Design Process Tie To Southwest Context and Simplify Facade

SECTION 3

DESIGN PROPOSAL

Revised 'Hyphen' Facade

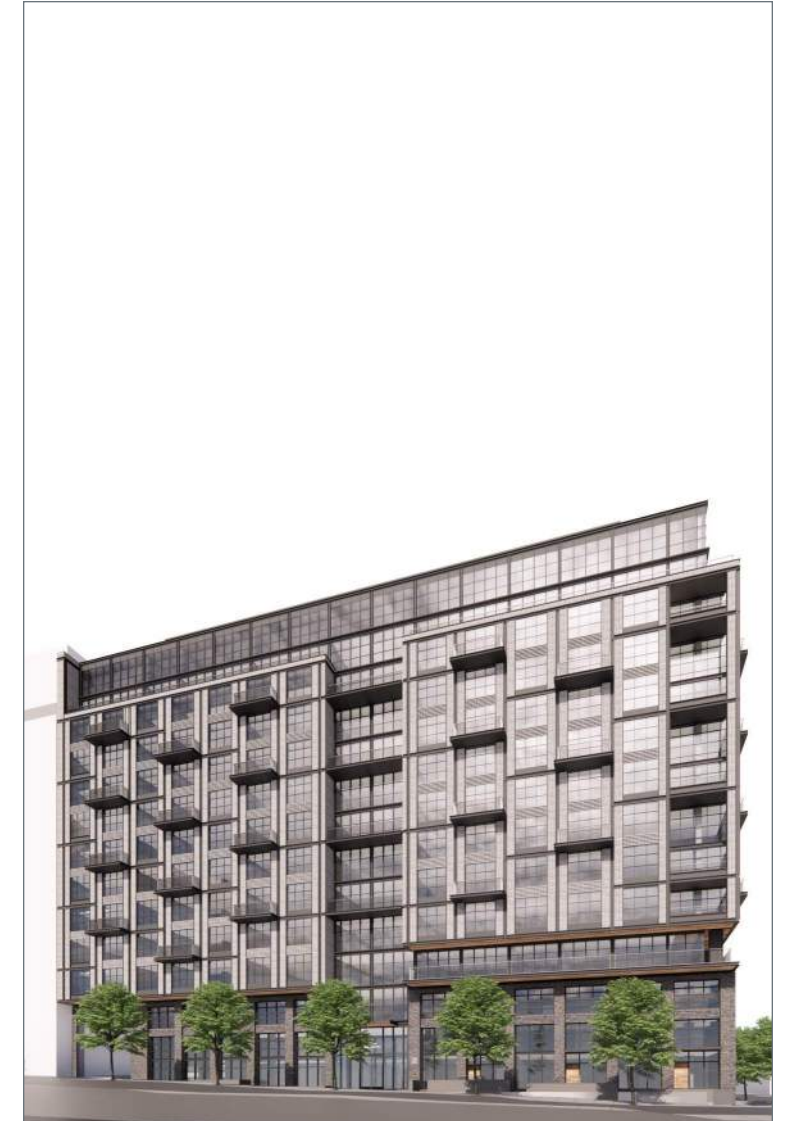
- Added balconies.
- Updated brick detailing to reflect the mid-century detailing prevalent in Southwest.
- Introduced additional reveals in the massing.
- Enlarged window openings / increased glass.

Design Process Tie To Southwest Context and Simplify Facade Exterior Details at North and West Elevations

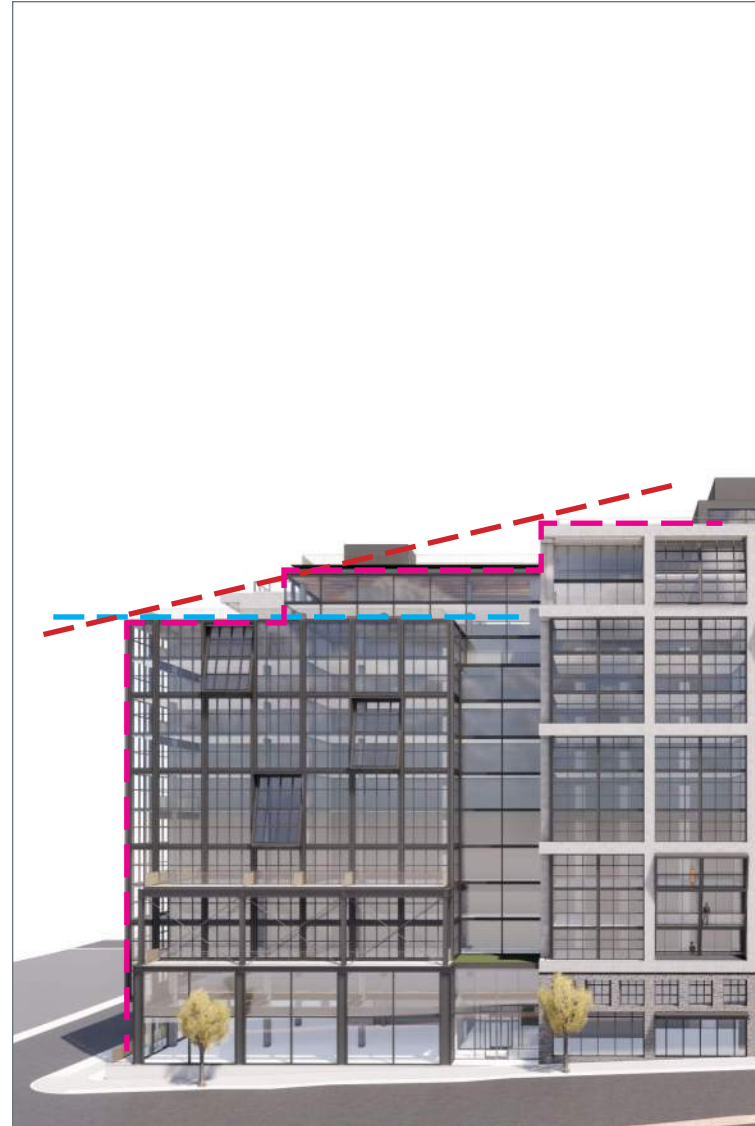
- Stacked bond brick creates a more mid-century aesthetic.
- Brick surfaces are captured by metal elements similar to mid-century references in the neighborhood.
- Increased glass and light.

- Replaced the dark charcoal brick with a lighter grey brick.
- Replaced metal spandrel with decorative brick.
- Revised balcony detail to evoke the rotated windows on the southeast building.

- Redesigned balconies to remove diagonal struts.

Revised Pavilion

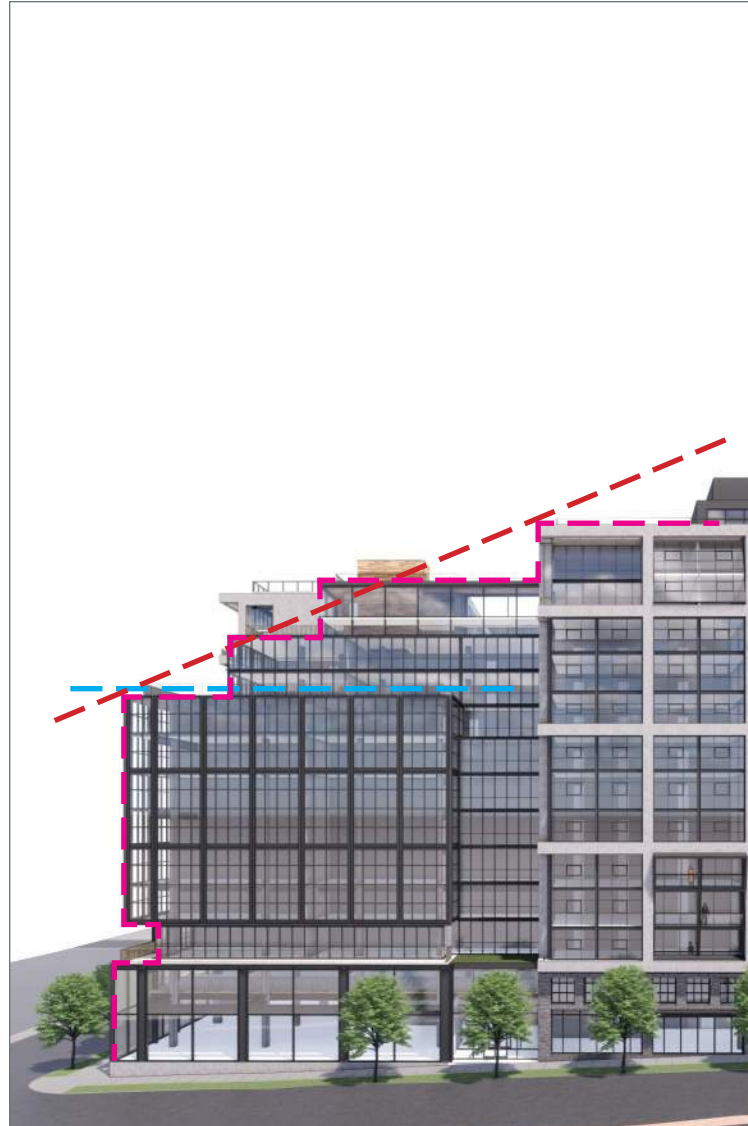
- Simplified the facade to exclude rotated windows and removed exoskeleton.
- Tiered the massing to allow for a more varied roofline.

Revised Pavilion

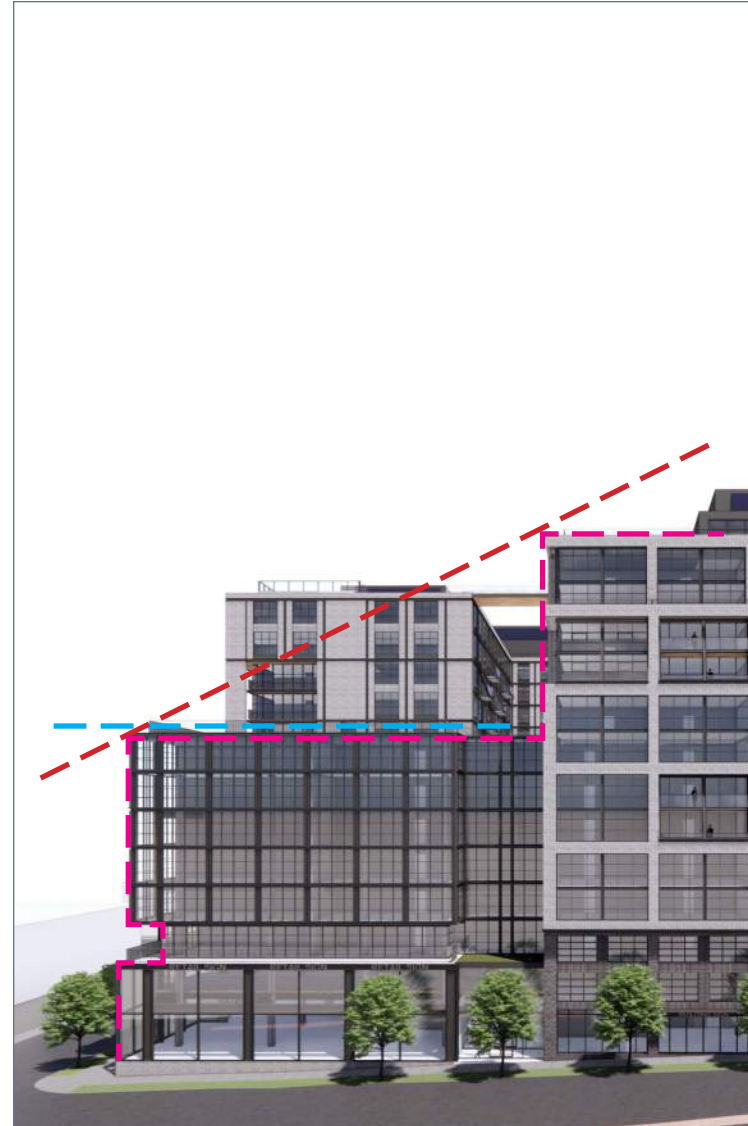
- Removed the tiering of the pavilion to allow for open air porosity to courtyard.
- Added 3-story inset for southern views.
- New inset corresponds with new outdoor amenity at pavilion roof.

Revised Pavilion Towers

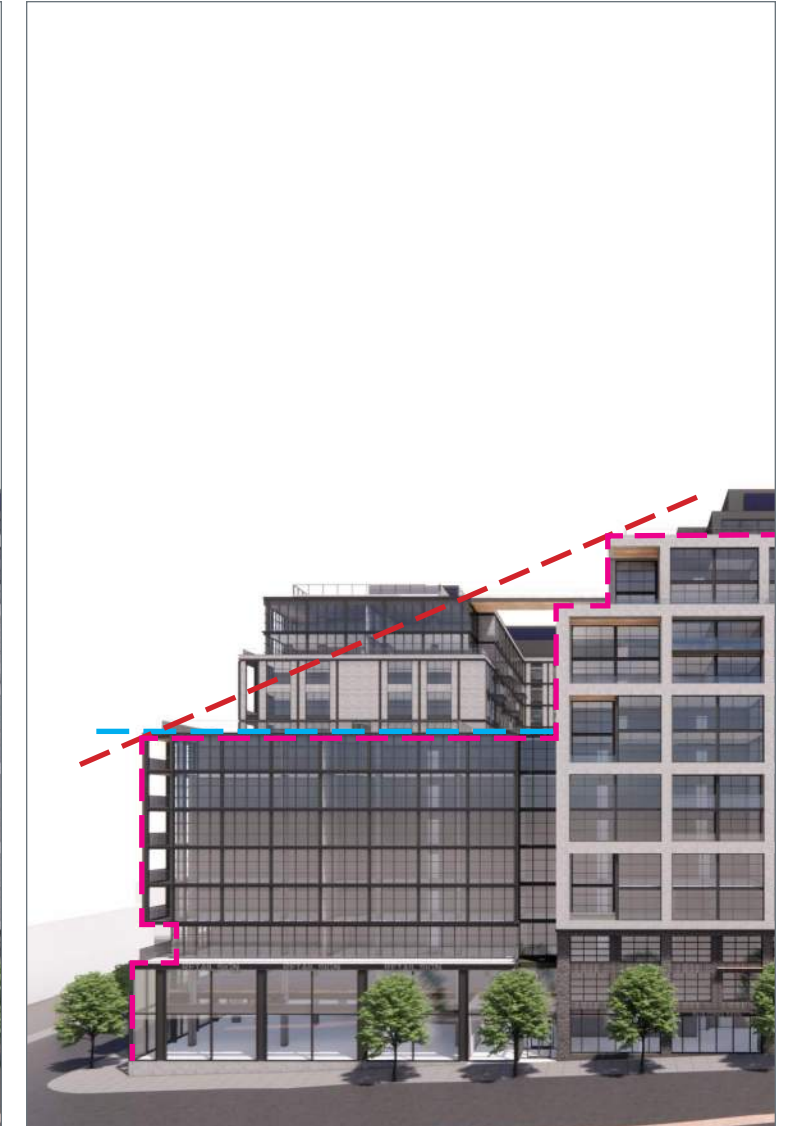
- Resized width and length of pavilion to simplify its relationship to towers.
- Added additional setback at south end of NW tower to step down into the lower rise Southwest neighborhood.
- Added additional setback at west end of SE tower to step down into the lower rise Southwest neighborhood.
- Simplified SW corner of tower to have inset balconies, bookending the tower with the same format of balconies as SE corner (and pavilion)

Revised Pavilion and Northwest Tower

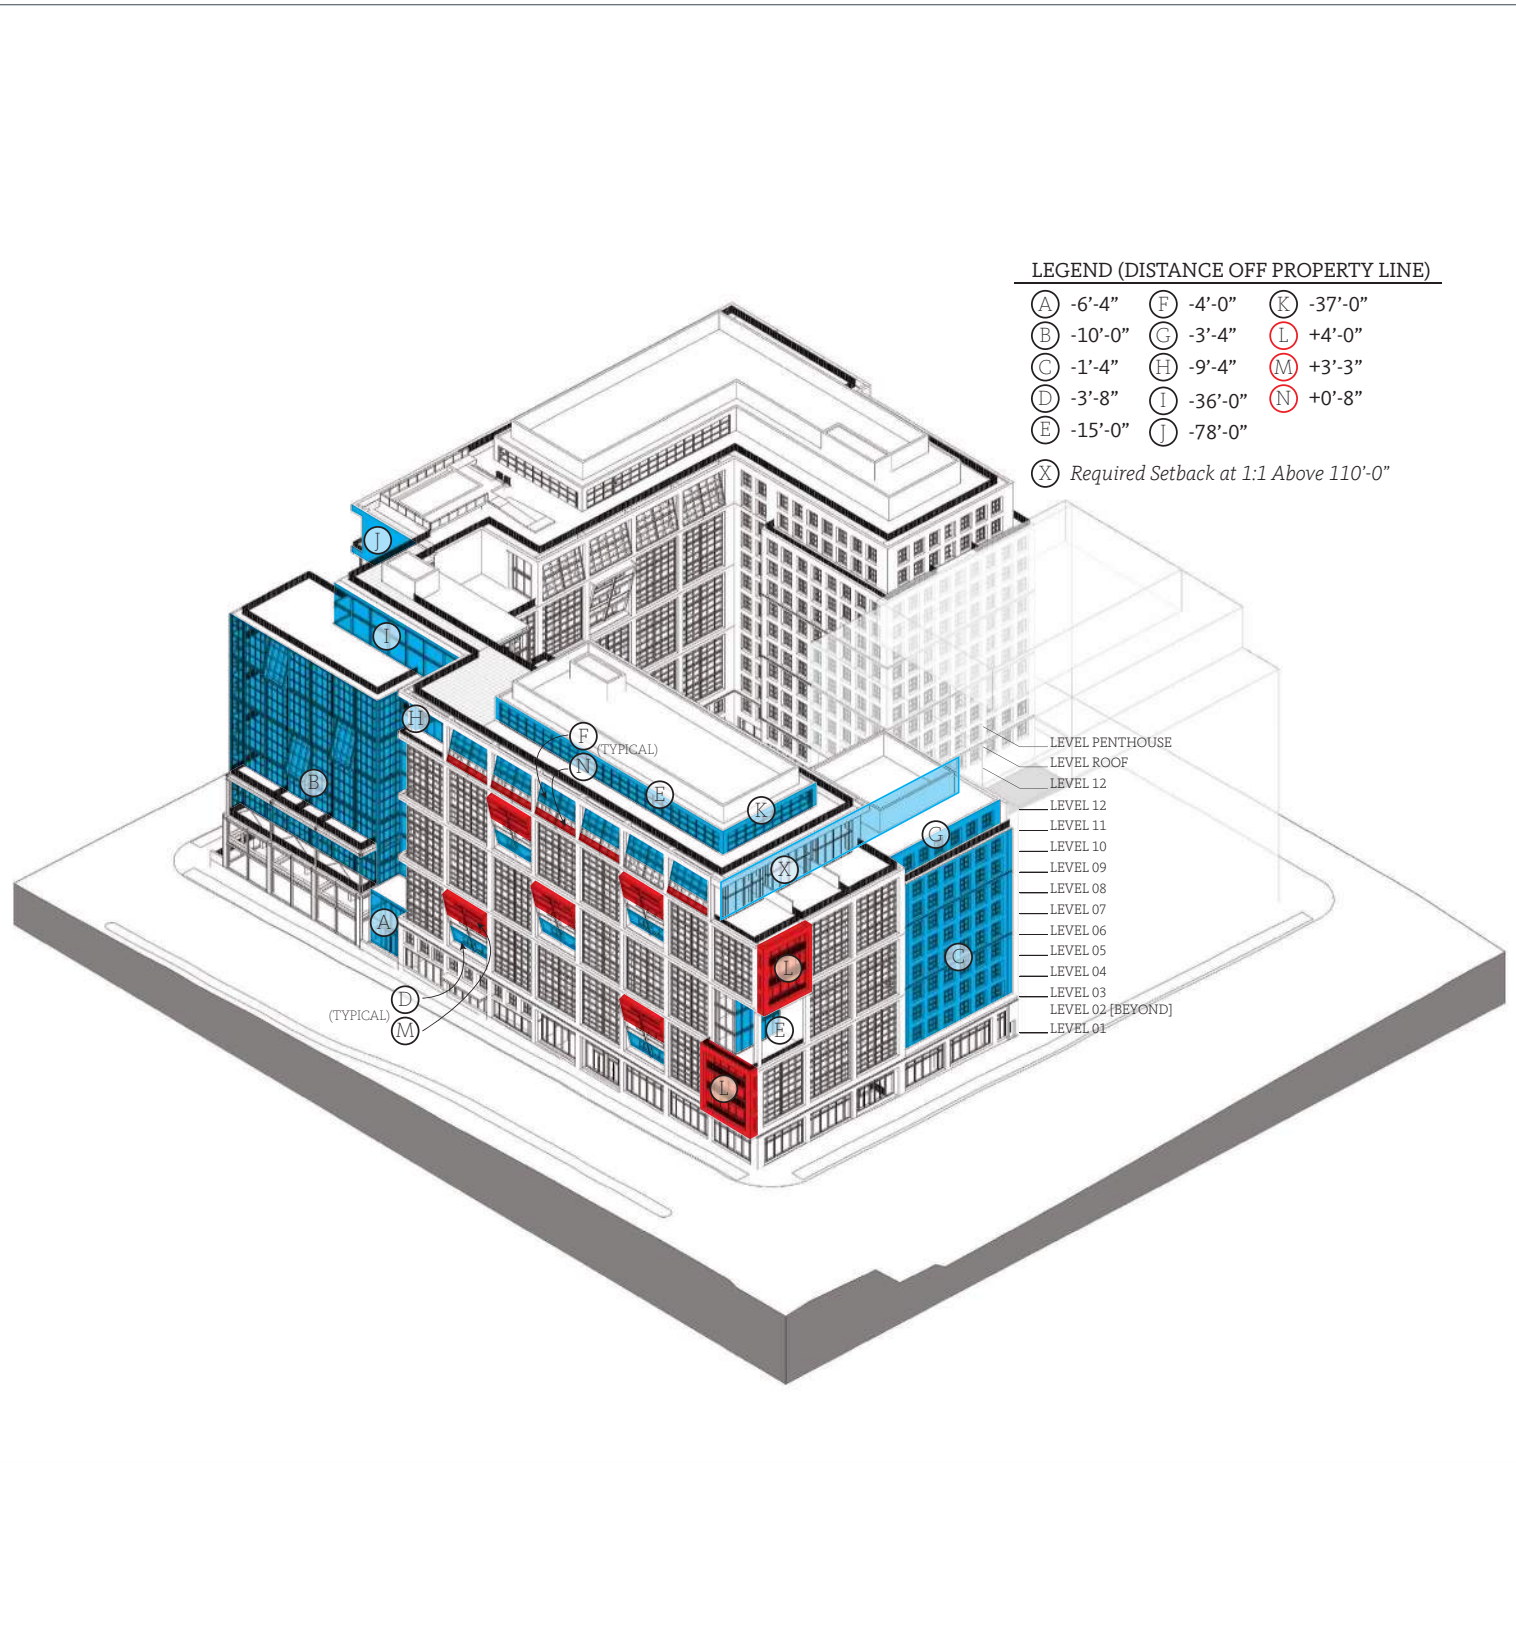
- Removed the tiering of the pavilion to allow for open air porosity to courtyard.
- New brick facade type consolidated to the northwest building
- Added balconies to west facade.
- Added 3-story inset for southern views.
- New inset corresponds with new outdoor amenity at pavilion roof.

- Resized width and length of pavilion to simplify its relationship to towers.
- Created inset balcony at outside corner of pavilion to match outside corners of towers (added balconies).
- Created inset balcony at outside corner of northwest tower to bookend the building, and to add consistency between towers and pavilion.
- Extended tower setback to full length and width of building at levels 12 and 13.

Revised Pavilion and Southeast Tower

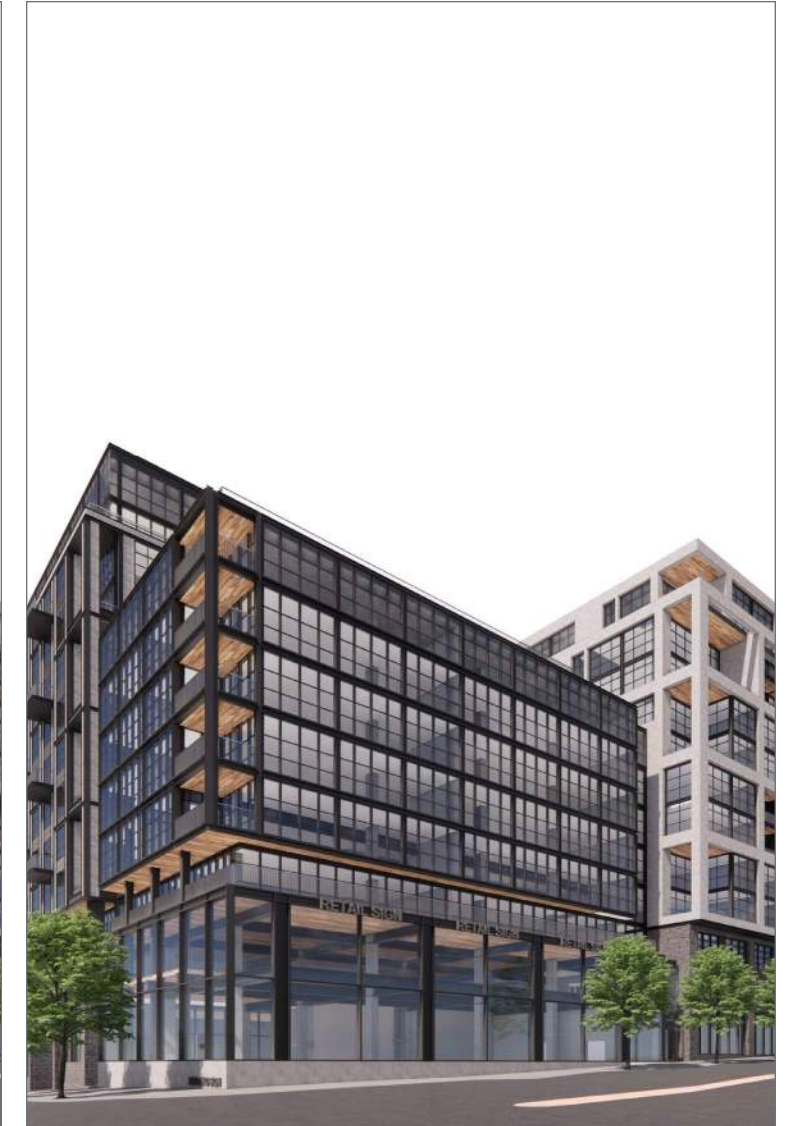
- Removed the tiering of the pavilion to allow for open air porosity to courtyard.

- Resized width and length of pavilion to simplify its relationship to towers.
- Created inset balcony at outside corner of pavilion to match outside corners of towers (added balconies).
- Simplified SW corner of tower to have inset balconies, bookending the tower with the same format of balconies as SE corner (and pavilion)

Revised Podium

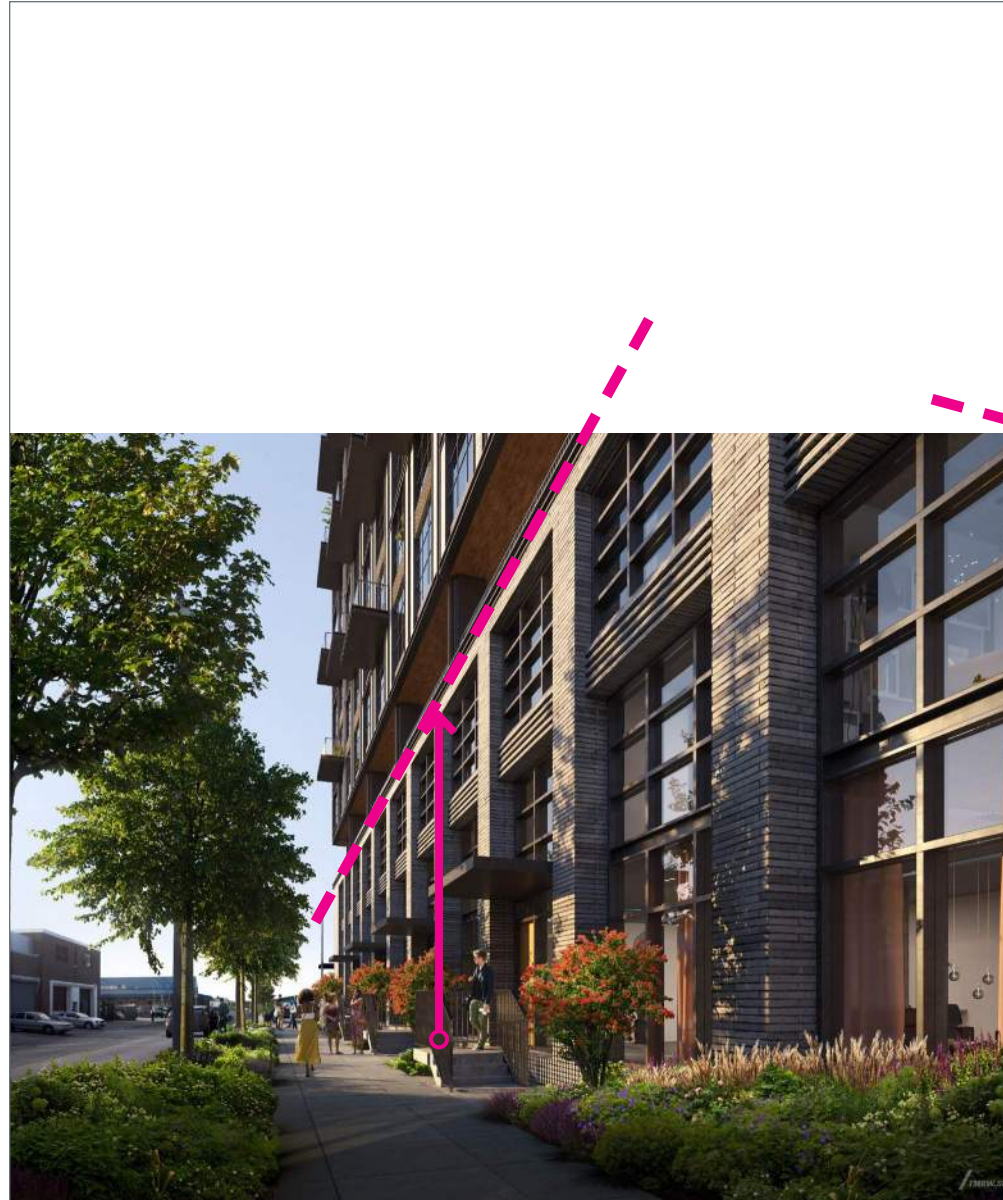
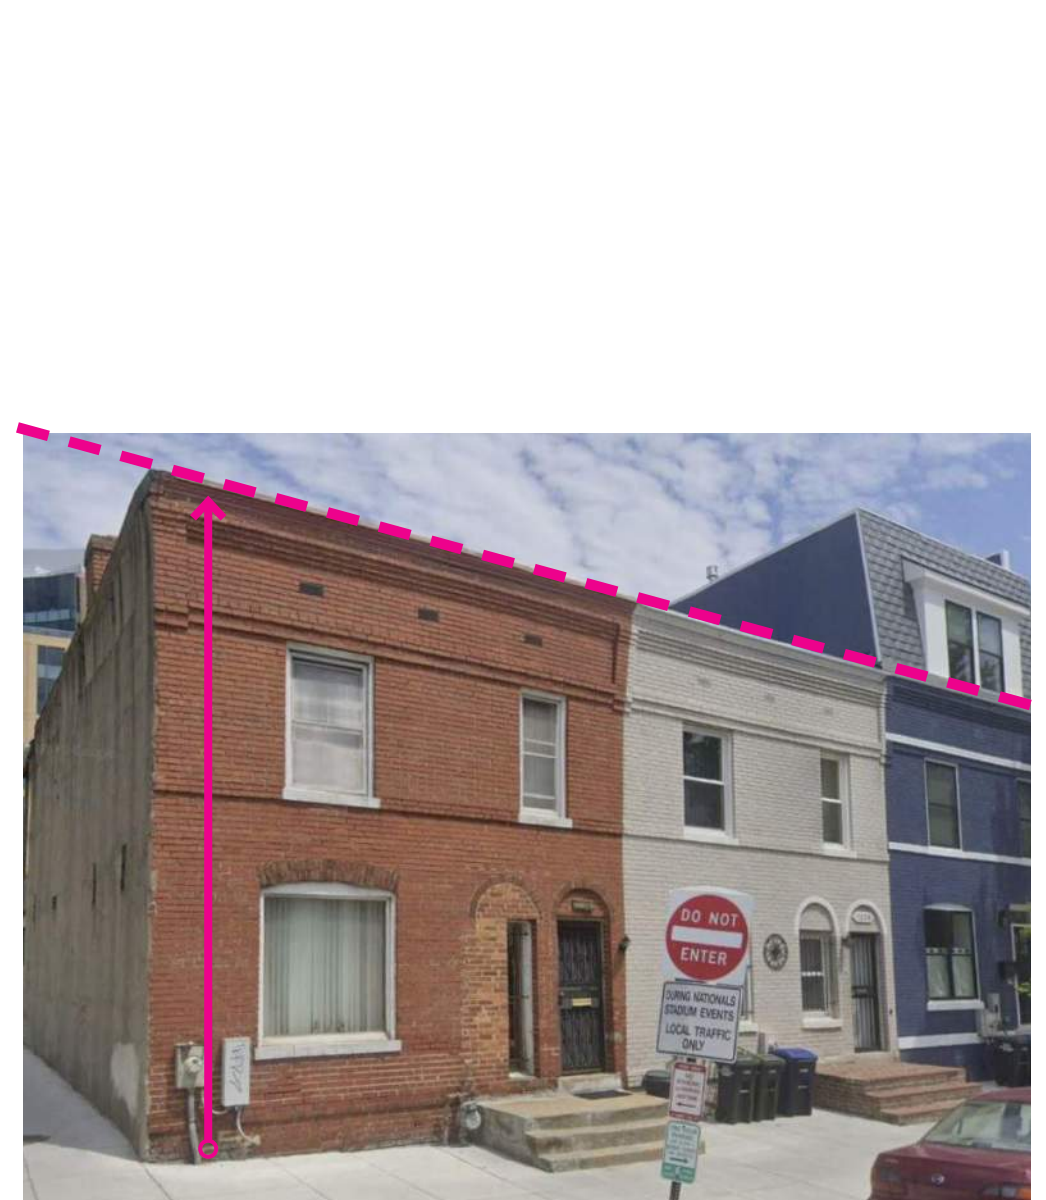
- Added a reveal at level 3 to better highlight a pedestrian-centric scale of the walk-up units.
- New reveal better associates the podium with low-rise neighbors.
